Instructions for Pad Wear Plate Kit P/N 300-5115

Notice:

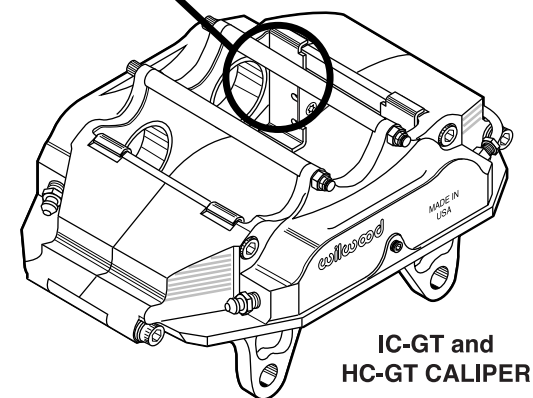
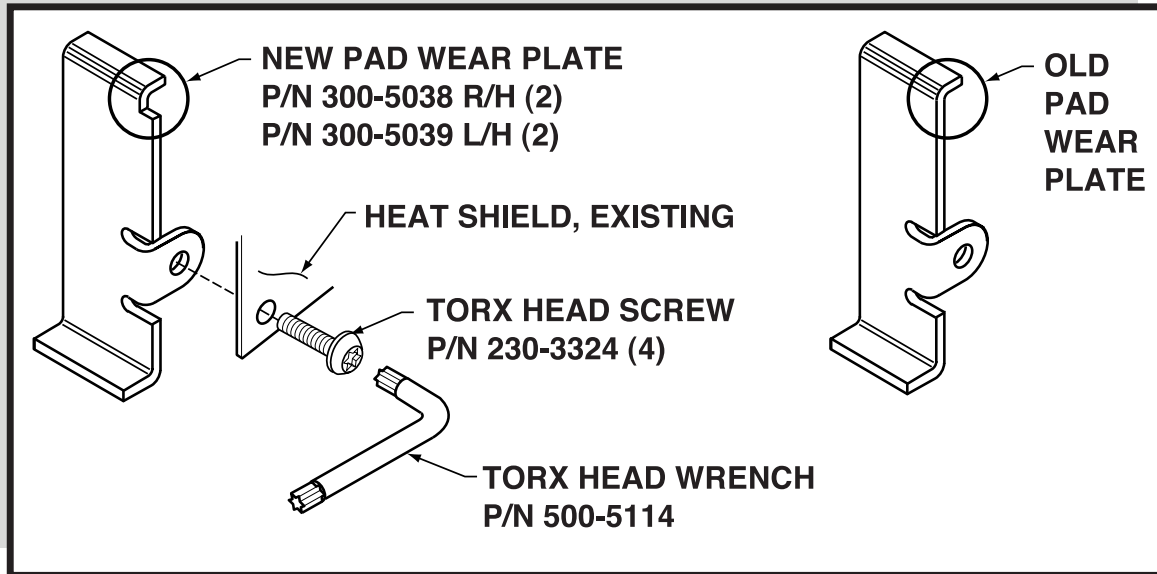
Install immediately the enclosed pad wear plates (P/N's 300-5038 & 300-5039) in all **IC-GT & HC-GT** calipers (P/N's 120-4690, 120-4691, 120-4920, 120-4921), replacing earlier version pad wear plates. These pad wear plates reduce the possibility of brake pads dropping out when friction material is worn to the backing plate.

Using the Torx head wrench, remove the screw that secures the pad wear plate on the inside of the caliper heat shield and slide out the existing pad wear plate. Take one of the new pad wear plates that corresponds to the mounting location of the one that was just removed, along with a new screw, and insert the plate in place while sliding the mounting tab under the heat shield. Secure in place with the new screw and tighten with the Torx head wrench. Repeat this procedure three more times on the remaining pad wear plates.
